### Panel & FC interface

DELTA LIST OVER PREVIOUS PINOUT RELEASED ON :

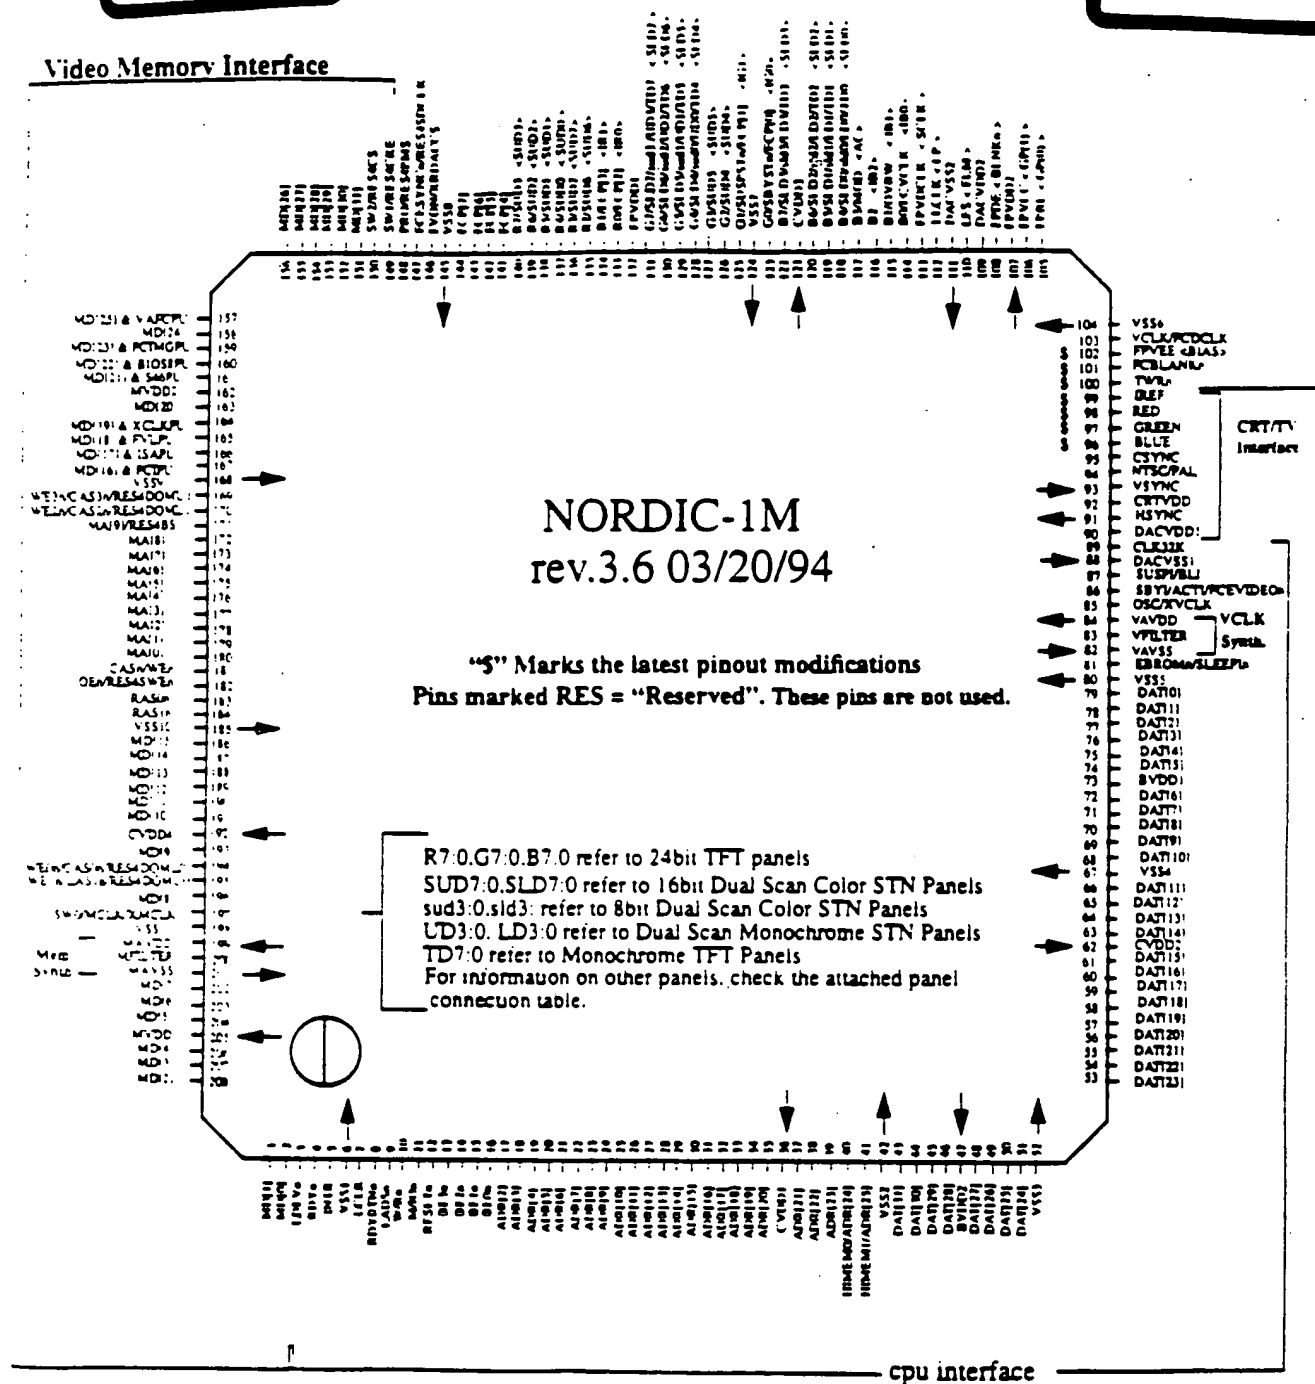
- no POUT on SW2/POUT
- XVCLK moved from SW1/VCLK/XVCLK to OSC/XVCLK. This way SW1/VCLK/XVCLK became SW1/VCLK.

- All panel pins whose names were not starting with the color panel name were changed such that the names start now with the color panel pin (R7, G7, B7 and so on). So it was only a pin name change.

1. Took-out Whisper Support Pins: WWRn, WRdn, WAD[3:0], FPCn.
2. Reduced the number of CPU Address Pins: ADR[24:27] went-away. Use HIMEM to place the chip outside 16MB of memory for linear addressing.

3. Killed CRTVDD and placed CRT Interface on Host Bus VDD.
4. Introduced VAFC pins in a unique pinout configuration in both VESA VL and PCI.  
Added VAFCPU a pull-up to enable VAFC (VESA Advanced Feature Connector).  
ADR[27:24] become VAFC pins, and R[7:4], G[7:6], CLK32K, SUSPI/BLI, SBYI/ACTI get a configuration for VAFC -> total 14 pins.  
SW0/VCLK will be used as VAFC DCLK, losing SW0 pin as panel type when VAFCPU is used.  
In PCI bus, no ADR pin will be shared with VAFC  
ASW0PU will be added on MD pins to replace SW0 pin when VAFC is enabled by VAFCPU. SW0PU will read-back in the same register bit as SW0, so the BIOS will not feel any modification in the reporting scheme. The chip will draw more power in suspend with VAFC.

5. Moved SW2, SW1/MCLK/XMCLK, the two RESERVED pins and TRWn on MVDD to prepare for SDRAM pin compatible option in the next Nordic that supports SDRAMs. It looks that we need only 3 more memory pins to support SDRAM-s so TRWn will not be used. It was moved so it is on the right VDD bus if needed.

6. Moved CVDD3, VSS3, VCLK Synth, H/VSYNC, EROMn, SW0 per Thomas Hung's request to fit the floor plan.

1. Added AUXS1 on D/Cn as an option to be used with CS4231S as CS.
2. Added AUXS2 on EROMn/VADRN as an option to be used for Sound Synthesizer Chip Select.
3. Rearranged 5428 FC pins due to a previous error: R5 and R4 should not be used with FC.
  - FCP[1:0] are shared with G7 and G6.
  - SW2 and the two pins reserved for SDRAM were moved in between Video Memory pins and Panel pins and one of them is used as FCESYNcn.
  - OVRW is shared with CLK32K, FCBLANKn is shared with SUSPI and FCEVIDEn is on SBYI.
4. Renamed the External Clock PU XCLKPU instead of XMCPU.

1. Moved some external pull-ups.
2. Added alternate pin functions on panel pins, as well as actual schematic name for engineering

1. Added TV-OUT (called also NTSC-OUT) pins on the panel pins

1. Added TVG on EBROMn/AUXS2 and took out VADR as an option on this pin.
2. Put back FCESYNcN on RES4SDCLK as an option (deleted by mistake).

1. Reset became RESETn, active L to correspond with the defined reset signal for VESA VL and PCI.
2. TFT Panels Data Pins R7:R0, G7:G0, B7:B0 changed and all pins got rotated to get them ordered from right to left. Due to this change now Ri=TVRi, Gi=TVGi and Bi=TVBi.

1. Update Panel Data Pins based on Robin's Table.
2. Move MOD pin on a Panel Data Pin used in 18bit TFT.
3. Move OVRW on a 24bit Panel Data Pin.
4. Removed pin configuration for TV-OUT support with digital encoders. All pins marked TV... were removed. As a result, some pins like LLCLK, LFS, FPDE, FPDCLK have one function now.

5. Removed WavePort pins, including AUDVDD: total 7 pins freed. AUX2 and TVG muxed on EBROMn are no longer needed either.
6. Added one more CPU address pin: instead of HIMEM, Nordic has now HIMEM0 and HIMEM1, corresponding to CPU Address 24 and 25 or any other external decode of the high order CPU address bits. In the process of adding this pin, most CPU Interface pins on the right side were moved to the right by one pin.

7. Added CRTVDD supplying HSYNC, VSYNC, CSYNC, NTSC/PAL CRT and TV Interfaces output buffers.
8. EBROMn is shared with TVON, the power-on signal for AD720. So, in ISA bus with on chip BIOS support, AD720 power on cannot be directly controlled by Nordic.

9. Added pins for Analog TV Encoder support - AD720 and MC1377
  - a. CSYNC = Composite Sync signal
  - b. NTSC/PAL = 1 -> NTSC, 0 -> PAL (for AD720, but it is TV Encoder Dependent)

- c. EBROMn/TVON (see #8)
10. ASW0PU "Alternate Switch 0 Pull-Up" pull-up on pin 155. MD[26] was removed, as SW0 is now not multiplexed.
11. De-multiplexed some of the pins previously multiplexed

- a. Pin 168 TWRn/RES4PMS is now RES4PMS, a pin reserved for synchronous DRAM support.
  - b. SUSPI/BLI/FCBLANKn is now SUSPI/BLI, not affected by the Feature Connector Enable Configuration

- c. As a consequence of b, pin 97 is FCBLANKn (not muxed with anything). Please note that FCEVIDEOn is still muxed with SBYI/ACTI as before, as Standby Input and Keyboard Activity are less important functions in a system.

- d. SW0 is no longer muxed on VCLK/FCCLK. So VCLK/FCCLK is a pin but it moved to pin 103 in the PVDD area, to be consistent with FC power supply.
12. SW1, muxed on MCLK/XMCLK (pin 197) became SW0. This is just a name change to have the switches placed in a more consistent manner.

13. SW1 is now muxed with a reserved pin: RES4CKE, pin 148, which before was totally reserved. The idea here is to go for pwpd with SDRAM-s for SW2 and SW1, while keeping SW0 on MCLK even with SDRAM-s.
14. Pin 147 is Reserved. It is actually one of the WavePort pins, but placed in-between Memory and Panel VDD busses (on MVDD) for maximum flexibility. To achieve this, the pins on its right were moved to the right by one. FPVEE <BIAS> moved down to pin 98 (it was 105).
15. TRWn is now by itself on pin 96, on FPVDD.
16. The names of all flat panel data pins reflect the panel type table attached to this document.

1. On EBROMn/TVON -> EBROMn/SLEEPIn with SLEEPIn an input which if L puts Nordic to sleep (as 3C3[0] and 46E8[3]).
2. TVON is now on RES, but TVON/RES is pin 146 and FCESYNcN/RES4SDCLK is pin 147.

1. Pin 148, RES4PMS which was a pin reserved for synchronous DRAM-s, got a function: it is now a programable output PRO and it is on FPVDD instead of MVDD. The intention is to optionally use this pin to control a switch between 5V and 3.3V, in which case a H level of 5V is desirable. My primary choice for this function is actually NTSC/PAL pin which is on CRTVDD, but if the TV-OUT option is used in a system and a switch between 5 and 3.3V is provided, PRO may be used.

1. Updated panel interface table with correct Nordic pin numbers. The pins shifted a bit in the last rev, but the panel interface table was not updated.

1. TVON pin can be configured as XRDACCS "External RAMDAC Chip Select", H if access to 3C6:3c9 but not for 3C7 IORD, otherwise L. This way Nordic can support External RAMDAC through the feature connector and generate a chip select for it, so that with minimal external logic a RAMDAC IORD and IOWR can be generated. In previous versions, EBROMn could be used as External RAMDAC Chip Select only in ISA, because in any other bus configuration EBROMn became SLEEPIn input. SR25[6] configures TVON pin as XRDACCS. At POST this bit is TVON but it is reset to L, so in both TV-OUT systems and External RAMDAC systems, this bit will have no effect until we need it to (in both cases the pin is active H).
2. TWRn pin name was wrong (was TRWn).

1. PCINBPU (PCI N0\_Burst Pull-Up) was replaced by PCIMGPU (PCI Memory\_Grant Pull-Up) on MD[23]. GRE[4] enables PCI Burst and the default is disabled. A pull-up on PCIMGPU extends Mem\_Gnt value from 250nsec to 500nsec, giving more time to Nordic to execute a Burst Cycle without retry. If PCIMGPU pull-up is hooked to MD[23], PCIPU is no longer needed, as both select PCI bus. This saves the need for two external pull-ups in PCI: only one external pull-up is needed to select PCI bus with reduced (MD16) or extended (MD23) Min-Gnt Value.

1. For RAMDAC Layout related reasons, IREF, RED, GREEN and BLUE moved down three pins. FPVEE, FCBLANKn and TWRn moved up to fill the gap. No functional change.
